Addendum No.: 3

Date Of Addendum: 5/21/2019

Rooftop A/C & Roof Replacement
300 Corporate Place
Rocky Hill, CT
BI – 2B – 387

ADDENDUM #3
**ROOF TOP A/C UNIT AND
 ROOF REPLACEMENT**
 300 CORPORATE PLACE, ROCKY HILL, CT
 Project No. BI-2B-387

MAY 17, 2019
SKM-01
 DRAWING REF: M-103

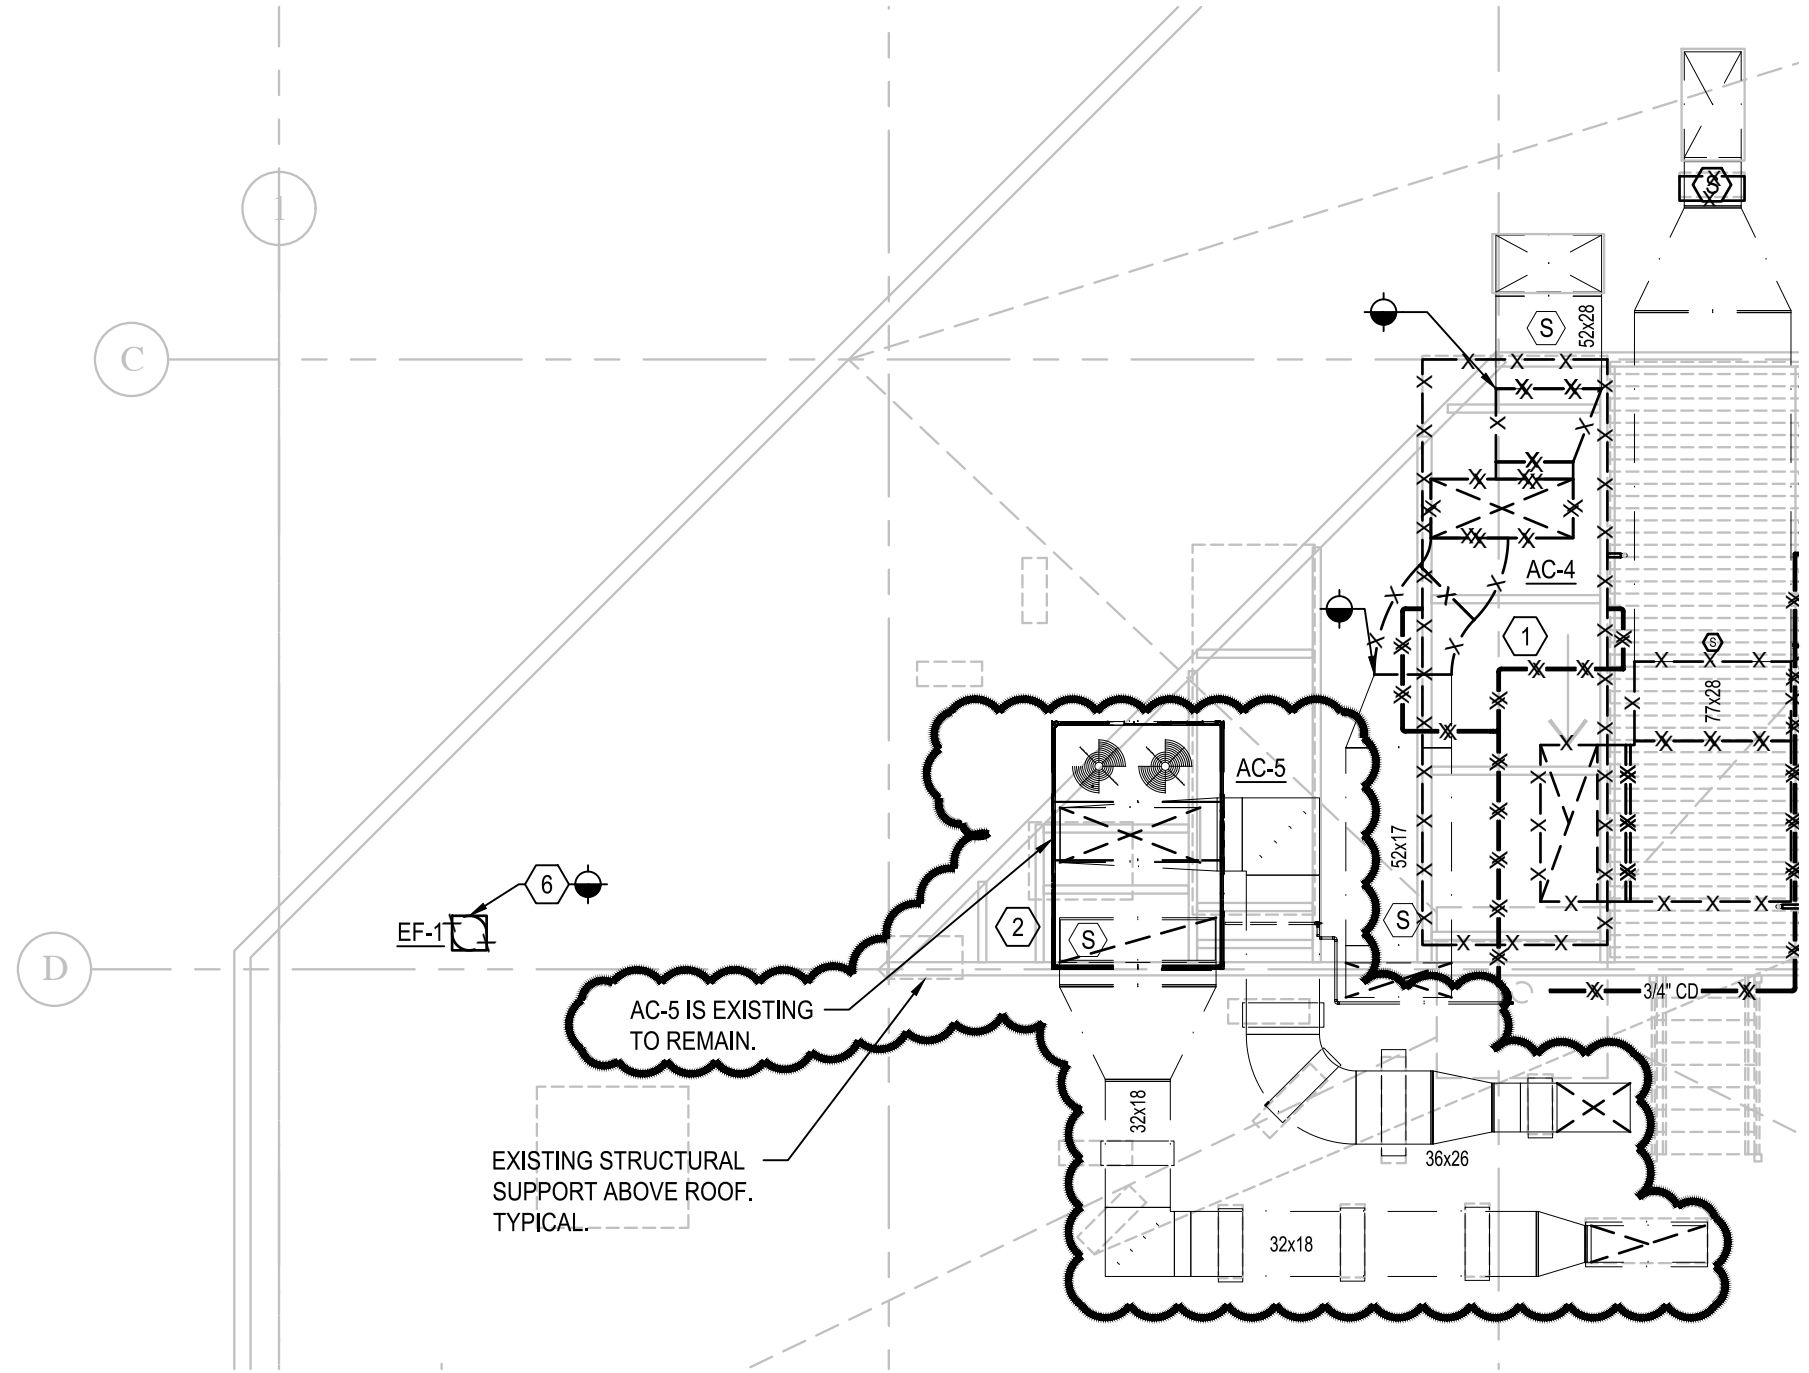
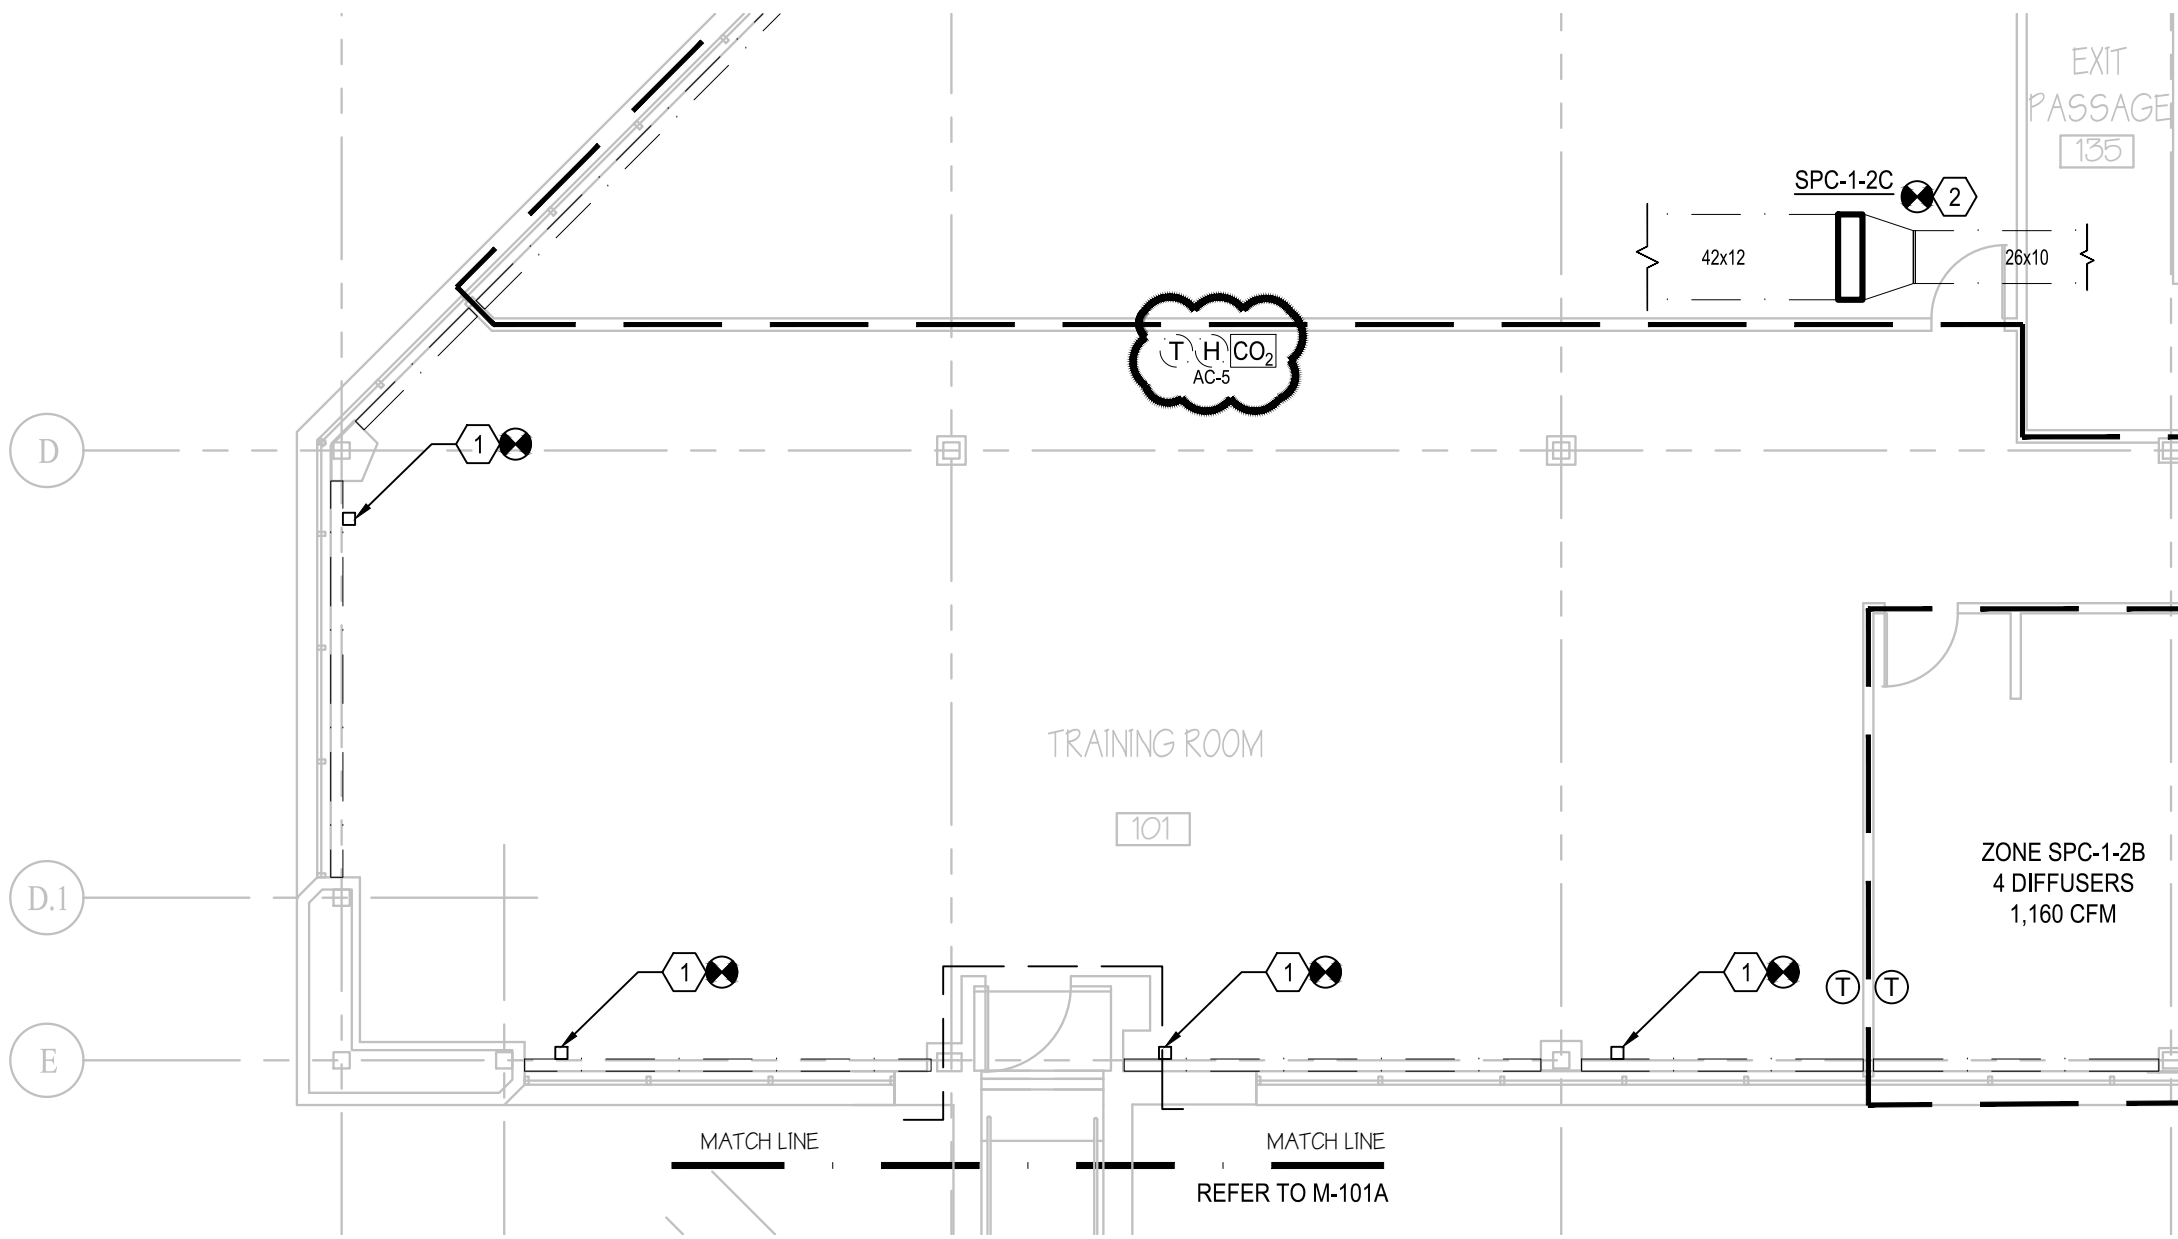
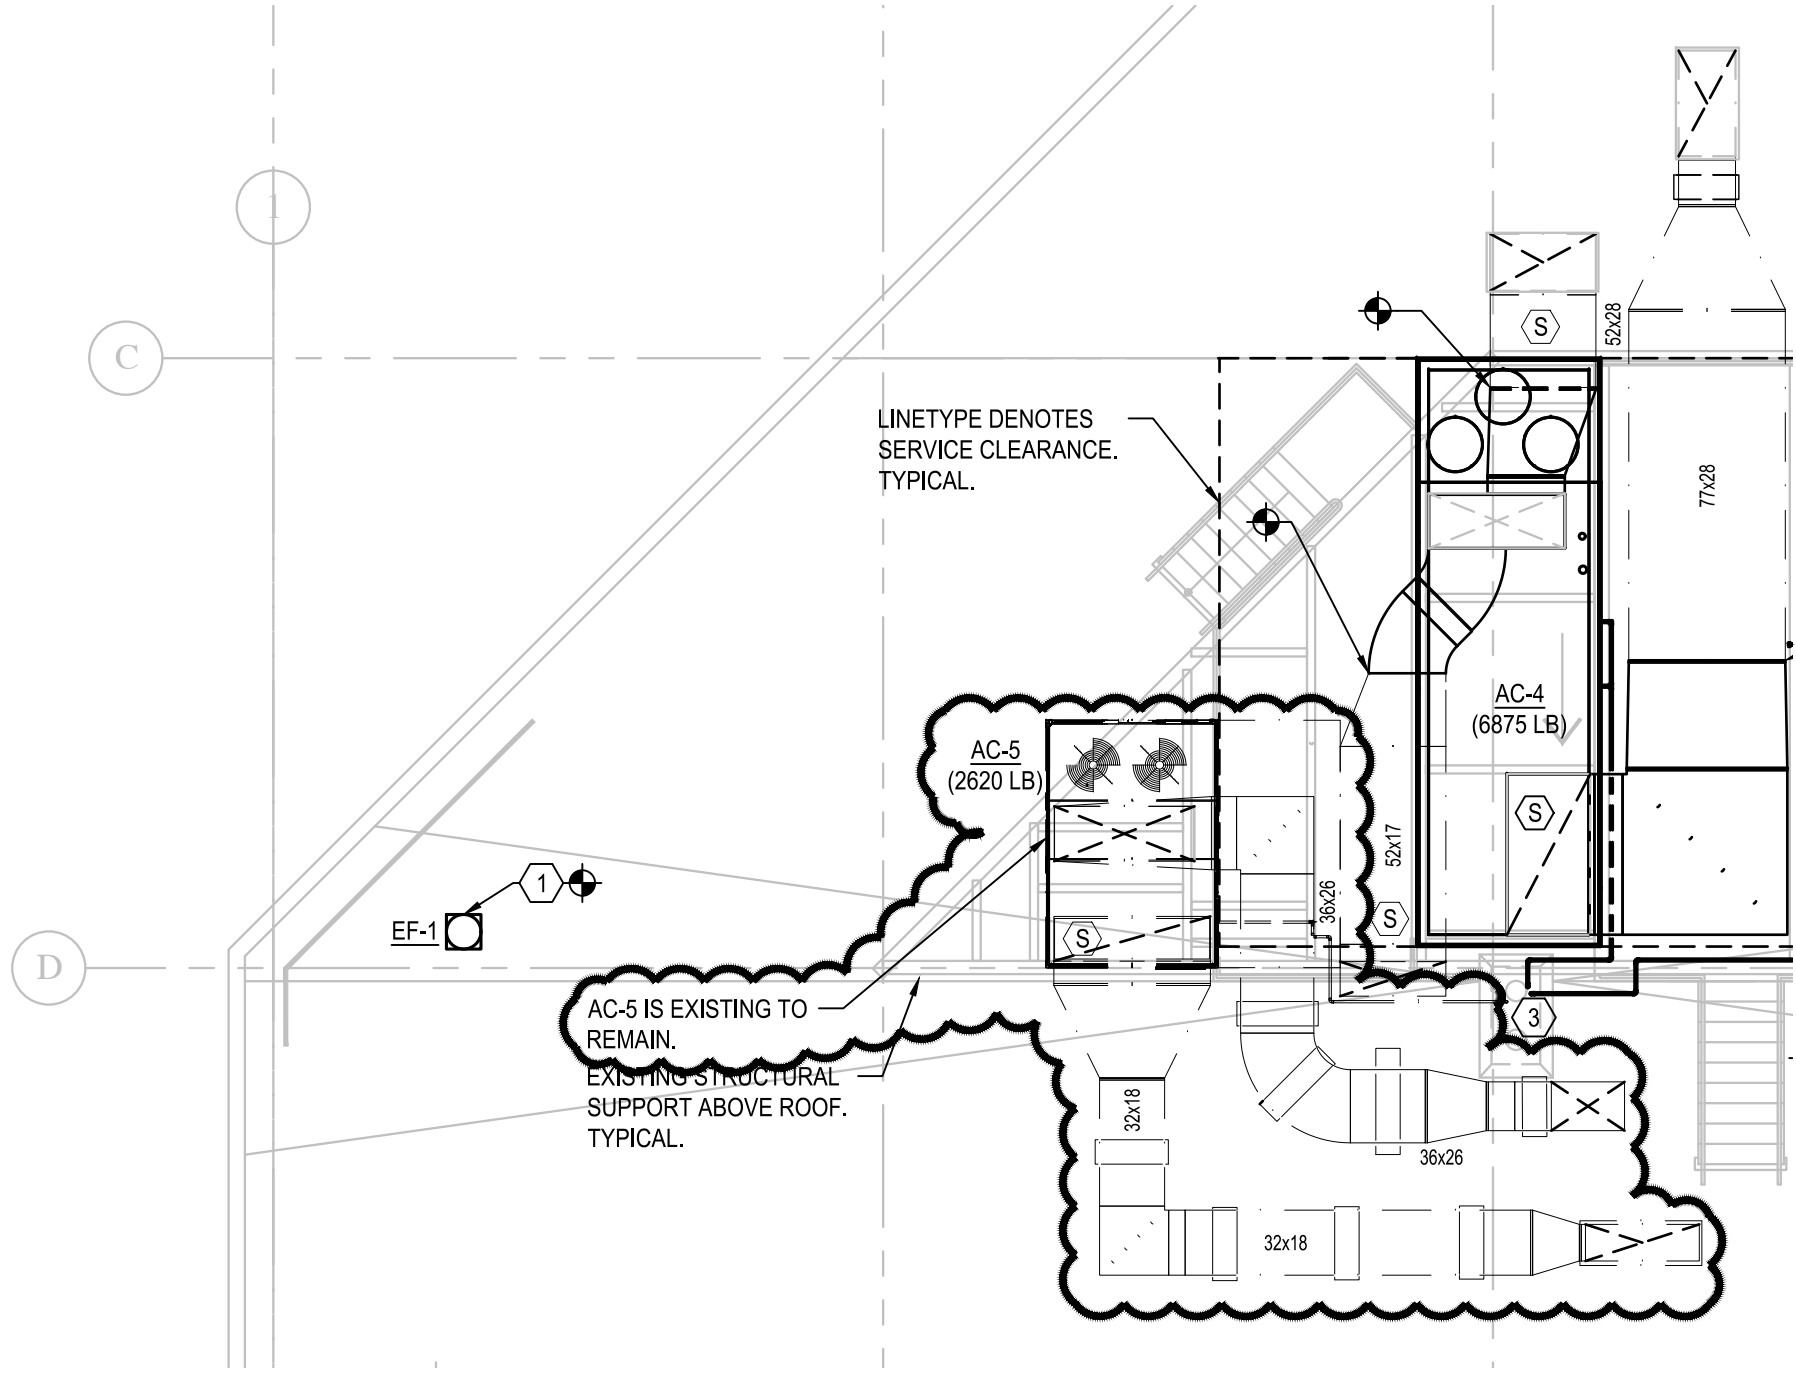
Revise Contract Drawings M-103 and E-103 with attached sketches **SKE-01** and **SKM-01** for location of TCP (Temperature Control Panel) in office 369 in order to provide proper clearances.
